City of El Paso – City Plan Commission Staff Report

Case No: SUSU14-00048 Cimarron Canyon Unit One
Application Type: Major Combination
CPC Hearing Date: July 3, 2014
Staff Planner: Alejandro Palma, (915) 212-1607, palmaaj@elpasotexas.gov
Location: North of Northern Pass Road and East of Resler Drive
Acreage: 90.17 acres
Rep District: 1
Existing Use: Vacant
Existing Zoning: R-3A/c (Residential/conditions)
Proposed Zoning: R-3A/c (Residential/conditions)
Nearest Park: Commercial # 1 (.02 miles)
Nearest School: Silvestre & Carolina Reyes PK-8 (.62 miles)
Park Fees Required: N/A
Impact Fee Area: Westside Service Area
Property Owner: Cimarron Hunt Communities, LLC.
Applicant: CSA Design Group
Representative: CSA Design Group

ATTACHMENT 3

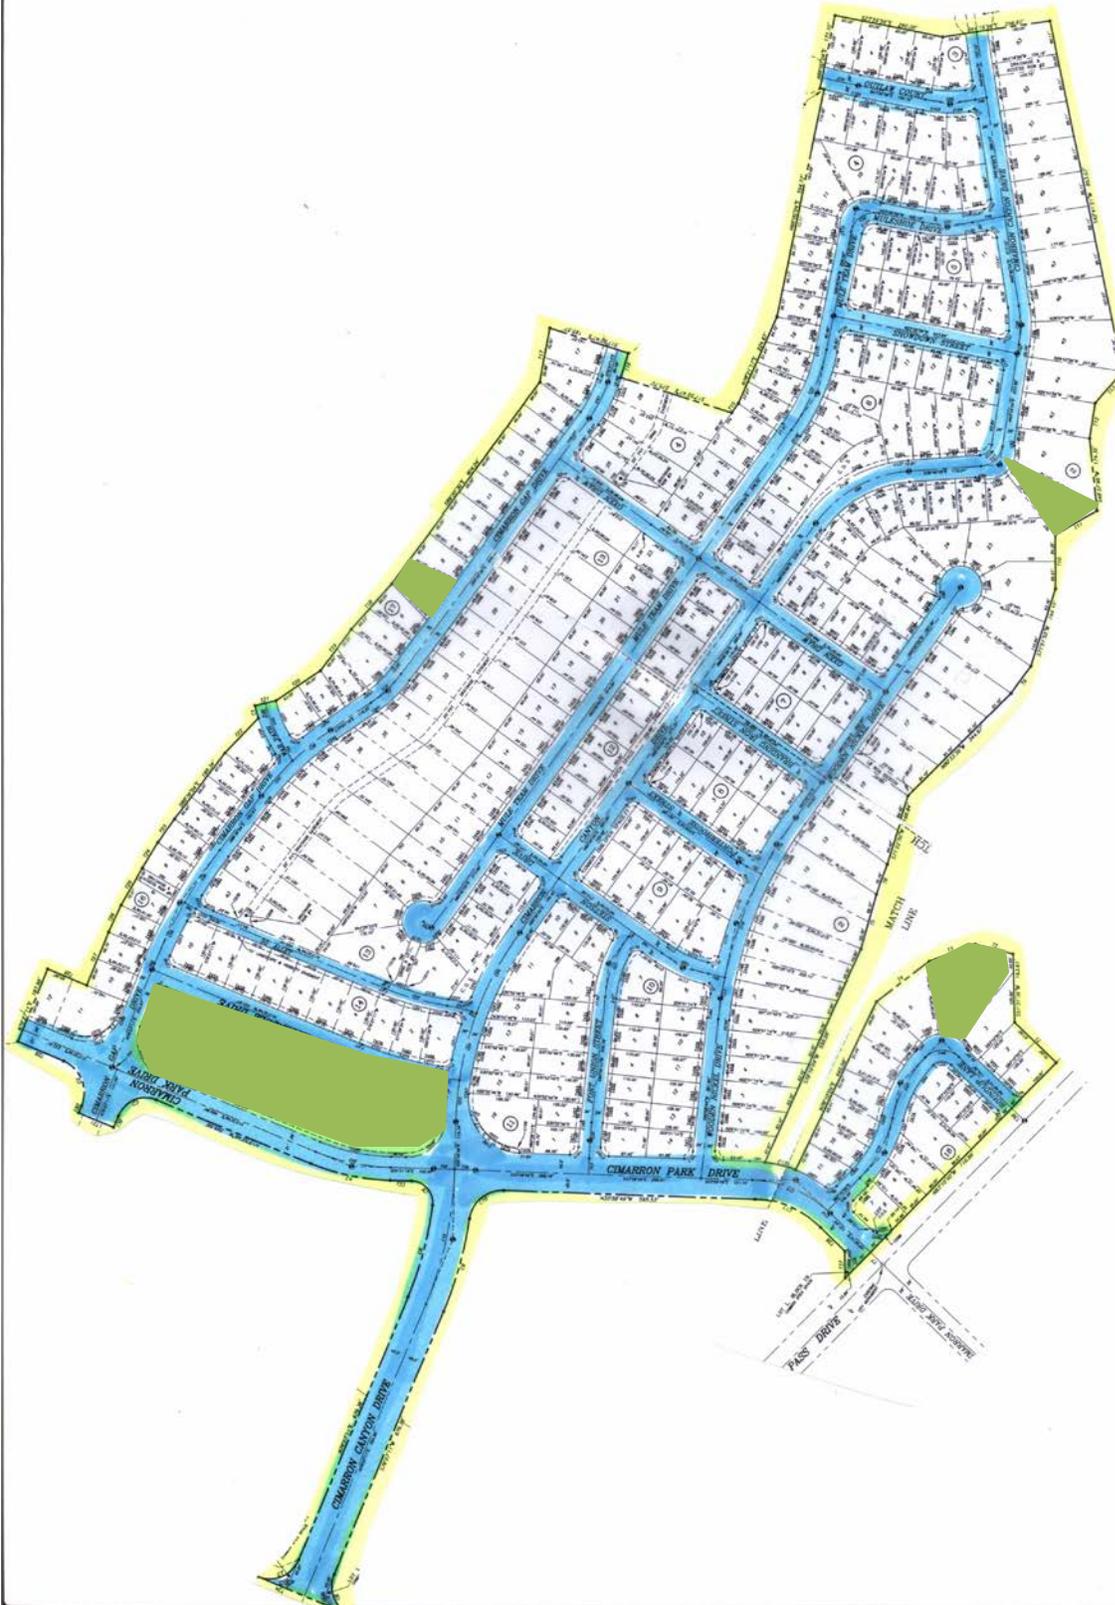
1. Label existing and proposed contours numbers legibly.
2. Label and dimension all proposed drainage improvements dimension drainage easement traversing through block #13 by bearing and distance.
